| <b>Proposal Descr:</b>          | DUT VEHICLE ACCESS GATE REPLACEMENT |                         |                                                                                                  |
| <b>Program Number:</b>          | SFAPT00692                          | <b>Addendum No.:</b>    | 01                                                                                               |

**ADDENDUM NO. 1**

UNALASKA AIRPORT  
UNALASKA AIRPORT VEHICLE GATE REPLACEMENT  
AIP 3-02-0082-024-2026/SFAPT00692  
CSPP OVERVIEW

SHEET  
4  
OF  
16

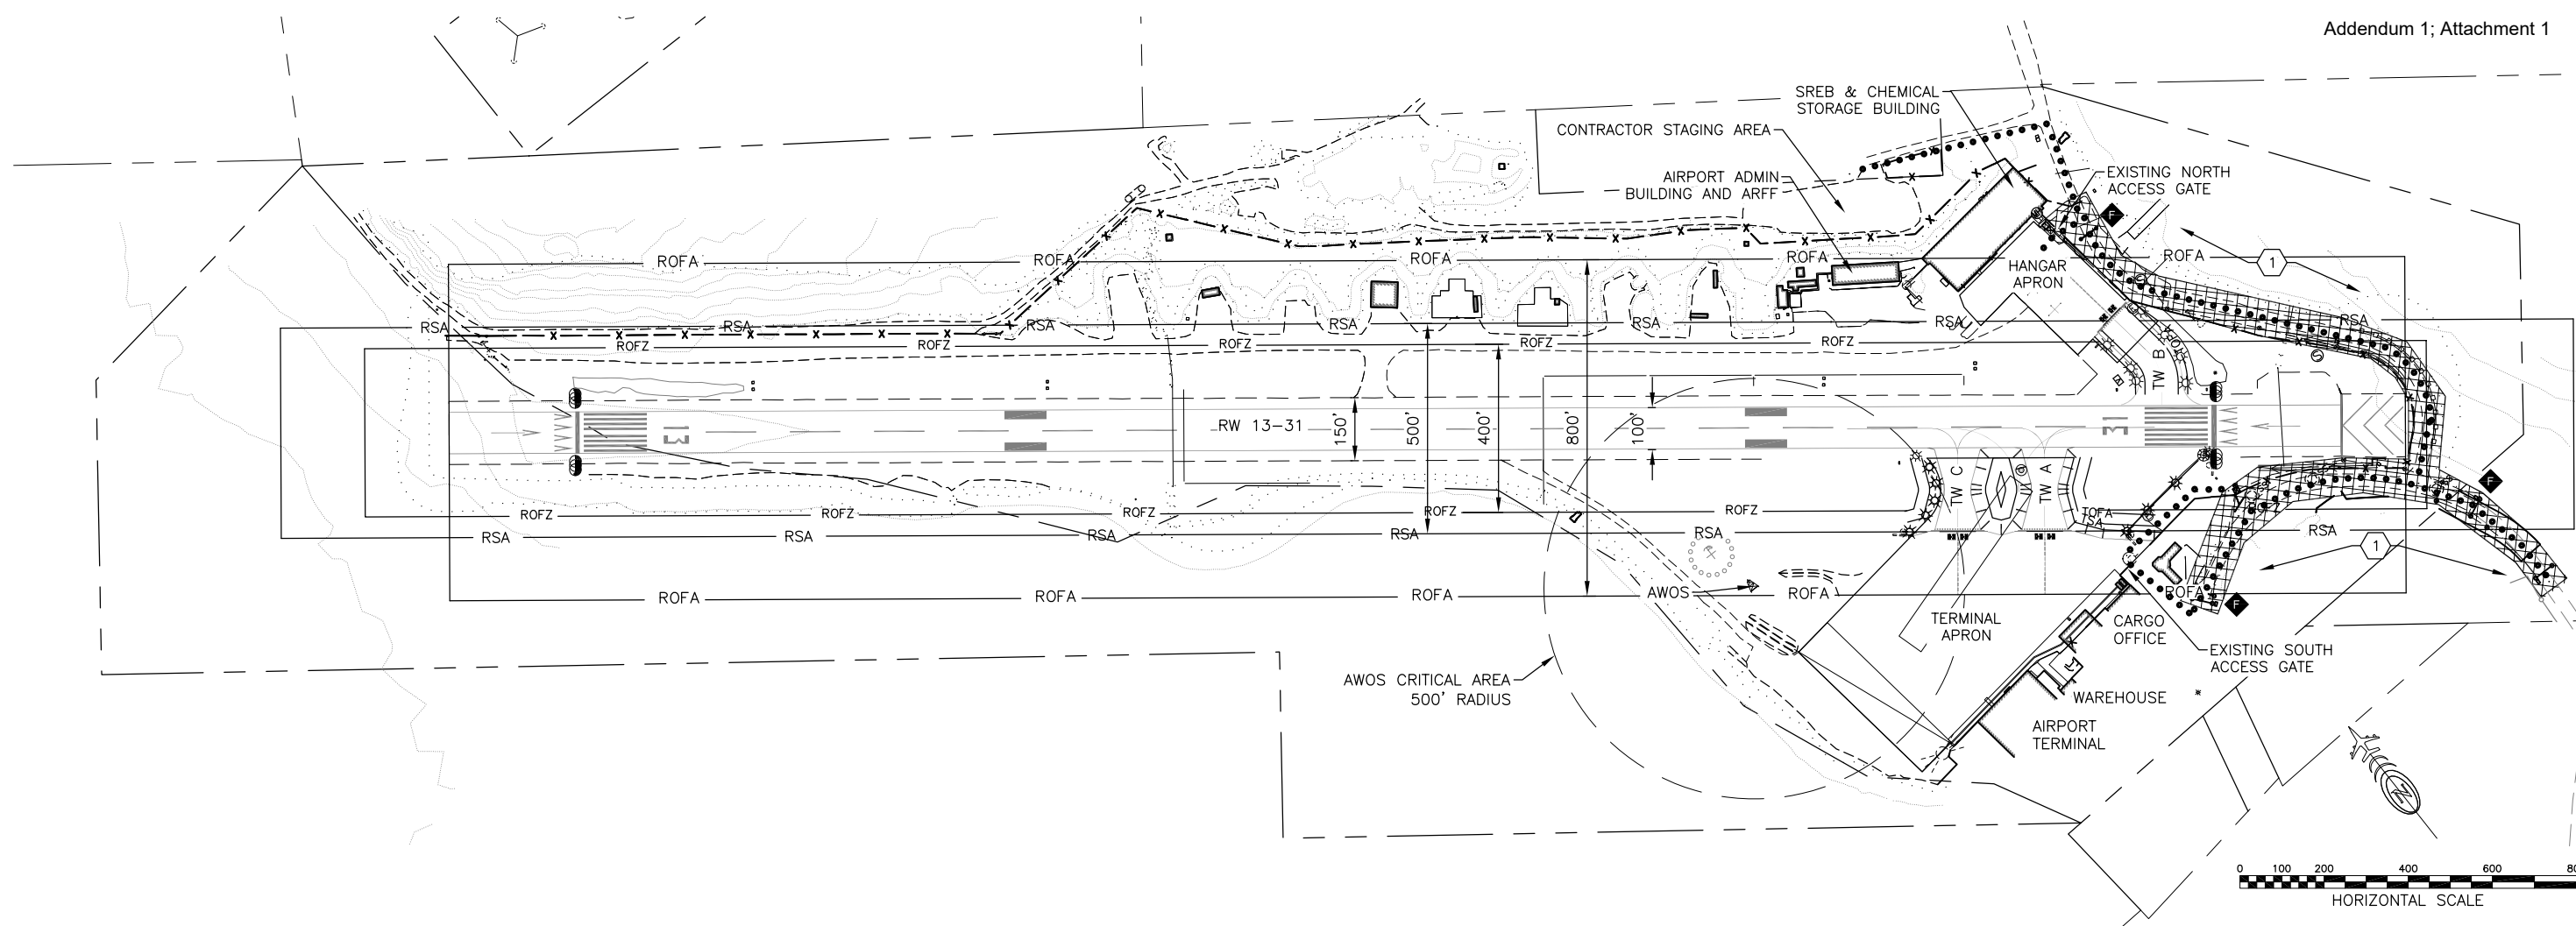
| EJG | 8/13/26 | 1 | REVISE PHASING SCHEDULE |

ANTICIPATED PHASING SCHEDULE

PHASE 1: REPLACE/RELOCATE GATES AND ASSOCIATED POWER SUPPLIES, CONTROL PANEL, AND CONDUCTORS.

SHEET  
14  
OF  
16

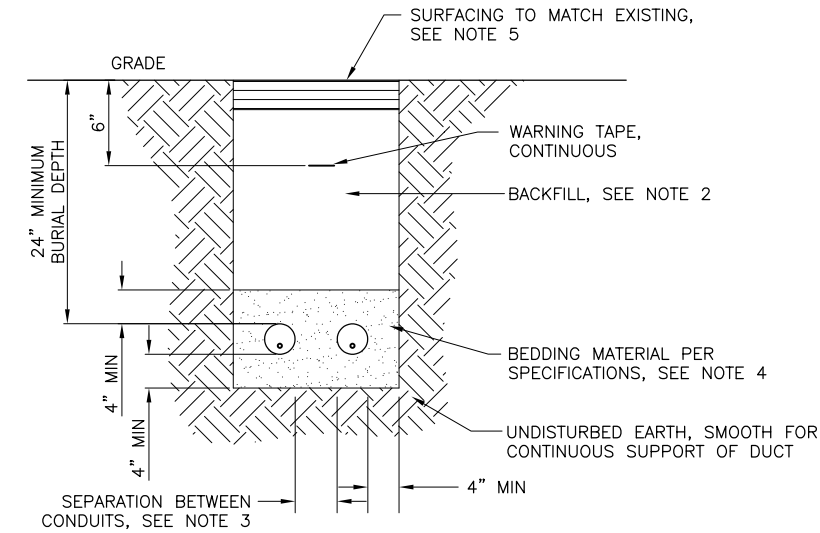
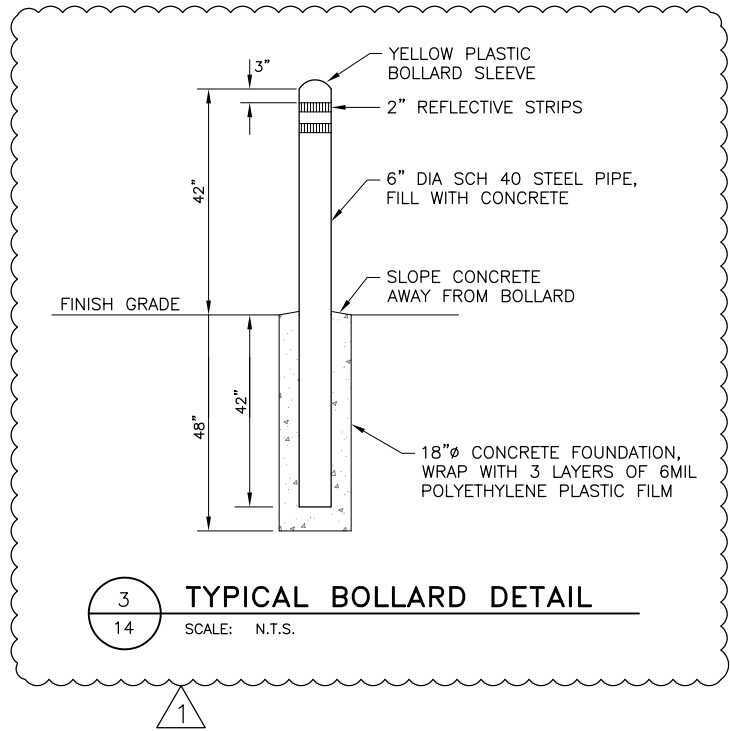
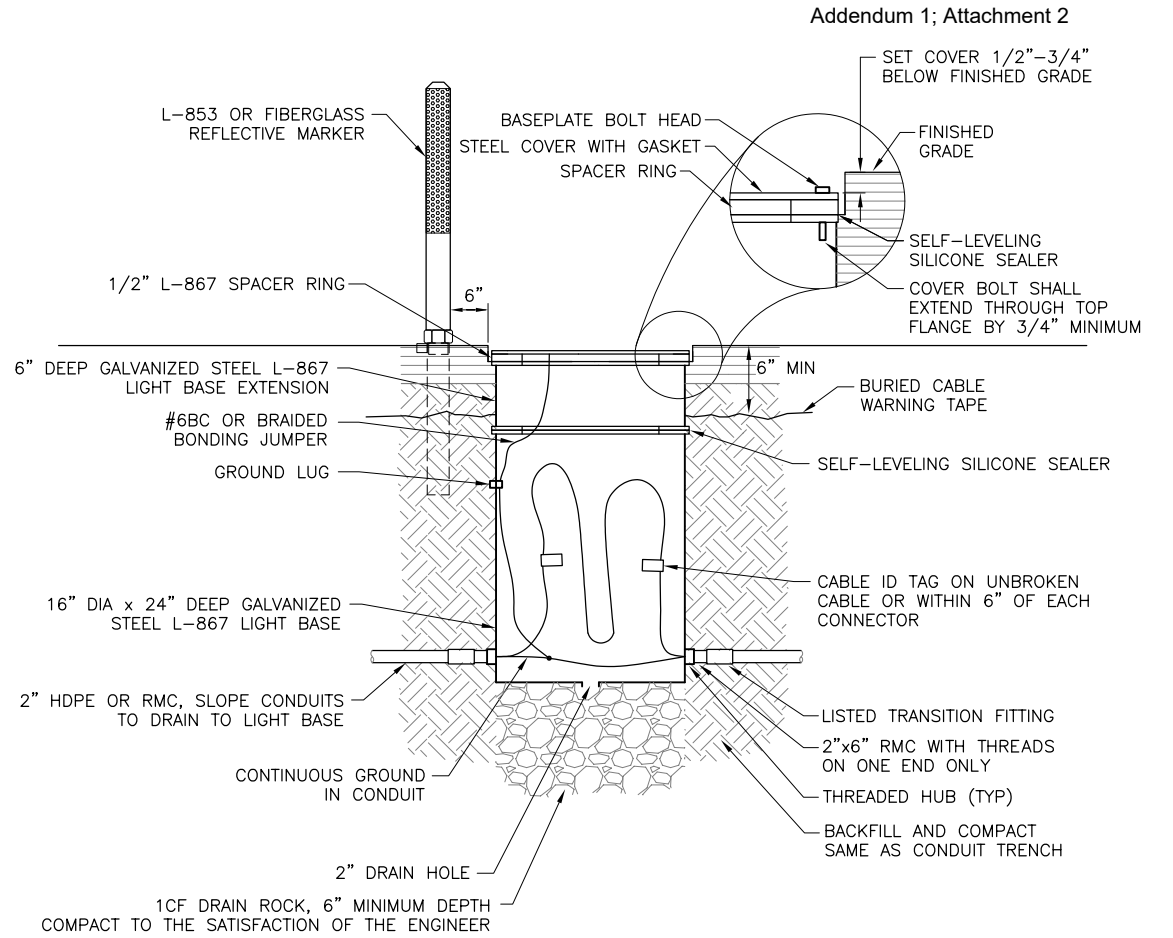
LPS 8/13/26 1 ADD BOLLARD DETAIL
